Sierra Nevada

Forest Protection Campaign

These comments on the proposed Kings River Project (“KRP” or “Project”) are submitted on behalf of the Sierra Nevada Forest Protection Campaign and the Sierra Club. (collectively, the "Campaign"). The Campaign previously provided scoping comments on this Project on or about February 2, 2005.

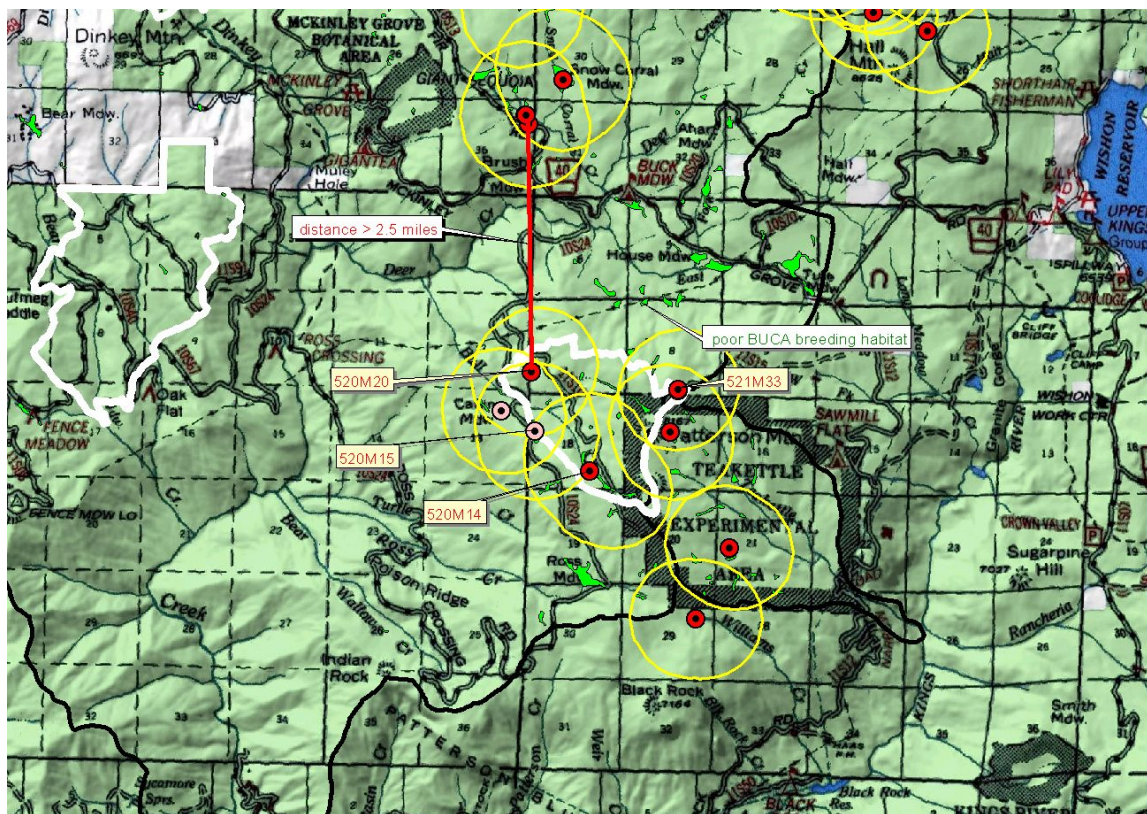
The resulting biological determination for the Yosemite toad of, “**may affect individuals and is likely to result in a trend towards federal listing or loss of viability**” (Aquatic BE p. 52) is directly tied to the rejection of important design measures discussed above and in (Sanders and Hopson 2005). In addition, the Aquatic BE p. 38, discusses the low likelihood of recolonization, if the population were to be extirpated (see below).

*To change the determination on the Yosemite toad to one that is not likely to lead to listing or loss of viability, a 500 foot no mechanical activity zone on occupied meadows (instead of the currently proposed 100 foot zone on meadows) would be needed.
